01A 5-speed

Transmission
* ■ modifications 35.16a

Manual Transmission – Case, Gears, Shafts

Transmission modifications

Main shaft needle bearing installation

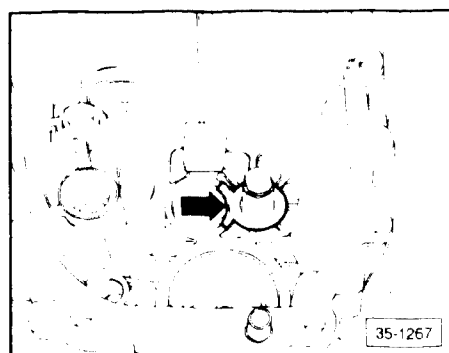
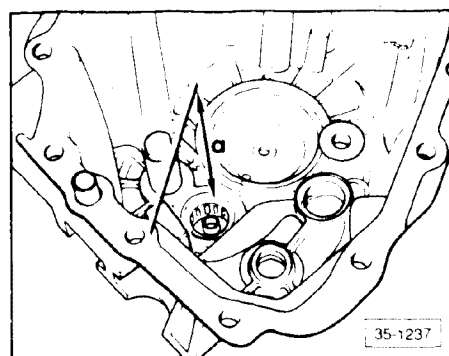
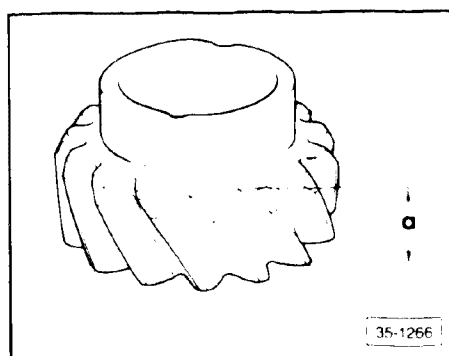
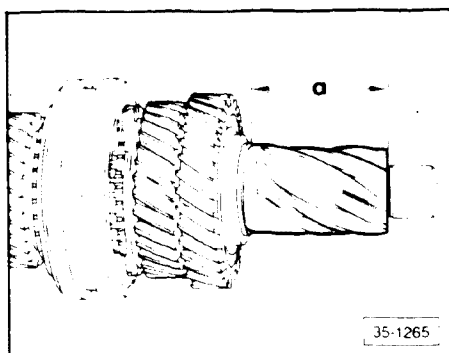
Beginning with transmission date 20 08 0, the reverse gear teeth on the main shaft and those of the reverse gear have been lengthened as follows:

- dimension **a** – current: 54.50 mm
New: 56.50 mm
- dimension **a** – current: 18.3 mm
New: 19.7 mm

Beginning with transmission date 20 08 0, the main shaft needle bearing in the final drive housing is installed 2.0 mm deeper.

- dimension **a** – current: 214 mm
New: 216 mm

The final drive housing is slightly milled-out in the reverse gear area (**arrow**).

The new mainshaft can be installed in earlier transmissions (before 20 08 0) but the needle bearing must be installed 2.0 mm deeper (see Mainshaft needle bearing installation on this page).

The new reverse gear can only be installed in transmissions that have the revised housing and main shaft.

Tensioning cable mounting

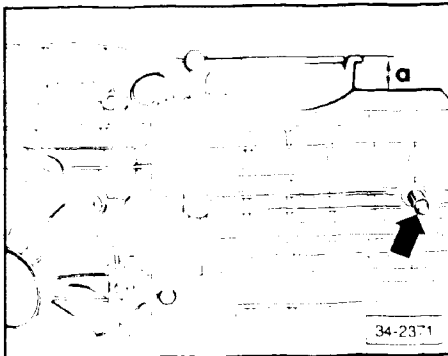
Beginning with transmission date 20 08 0, the tensioning cable mount on the transmission was changed.

- dimension **a** – current: 23.5 mm
New: 31.5 mm

Beginning in 9 90 a mounting hole in the housing replaces the previously used mounting stud (**arrow**). The tensioning cable bracket is then provided with a mounting stud.

Change the cable bracket when installing a new transmission.

Rear pinion needle bearing deleted

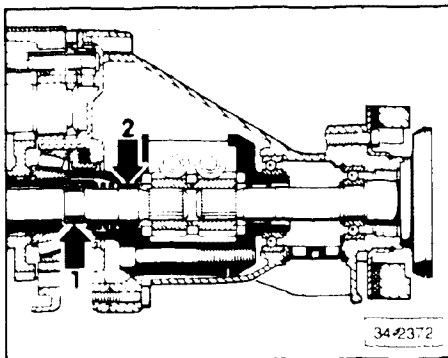
Beginning with transmission date 24 08 0, the rear needle bearing (**arrow 1**) is deleted.

The pinion is now supplied with a needle bearing in the Torsen differential (**arrow 2**).

The pinion and Torsen differential with the revised bearing can only be installed together in a current transmission.

The shaft is not machined in the area of the current bearing seat (**arrow 1**). It can only be installed together with the revised pinion and Torsen differential in current transmissions.

Additional magnet in Torsen differential cover

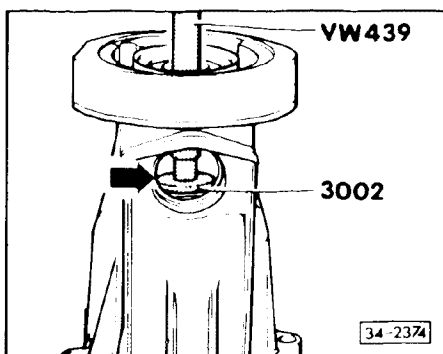
Beginning with transmission date 24 08 0, cap **A** is provided with magnet **B**, which is in sleeve **C**

Hollow shaft circlips, revised

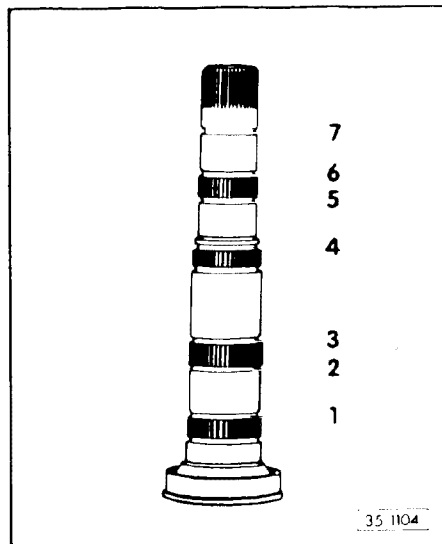
Beginning with transmission date 03 04 0, the circlip sizes are revised as follows:

Thickness of circlip (mm)	Part number
1.90	N 902 946.02
1.94	N 902 946.09
1.98	N 902 946.10
2.02	N 902 946.06
2.06	N 902 946.11

Thickness of circlip (mm)	Part number
1.86	N 902 952.07
1.90	N 902 952.02
1.94	N 902 952.08
1.98	N 902 952.09

The circlips 1, 2, 5, 6, and 7 remain unchanged.

New circlips can be installed in all current transmissions.

Current circlips will be deleted when supplies are used up.
